DVX-1000
(DVR-1000)

Number: 09.12ce 1/2

Substitute Parts Introduction for Traverse Unit

(Fig 1)

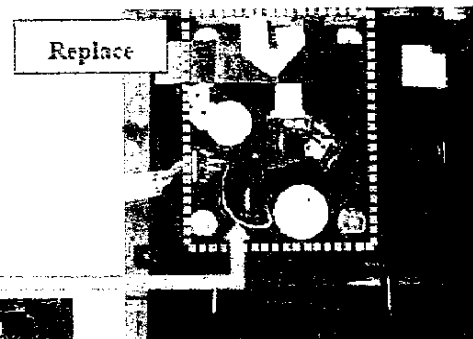
- 1) Remove 4 screws mounting traverse unit in "WQ467000" together with cable and cushion rubber. (Fig 1)
- 2) Replace original traverse installed in the loader ass'y for DVX-1000 with the substitute traverse unit removed from "WQ467000". (Fig 2)
- <Note> Original screws and cushion rubbers in DVX-1000 should be used.
- 3) Be sure to remove solder short for electrostatic damage prevention. (Fig 3)
- 4) Other procedure is the same as instructed in service manual.

DVD MECHANISM UNIT (WQ467000)

① : Screw, Cushion rubber
② : Cable

Traverse Unit
(Fig 2)

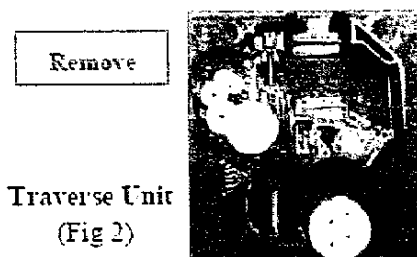
LOADER ASS'Y for DVX-1000

Replace

Remove
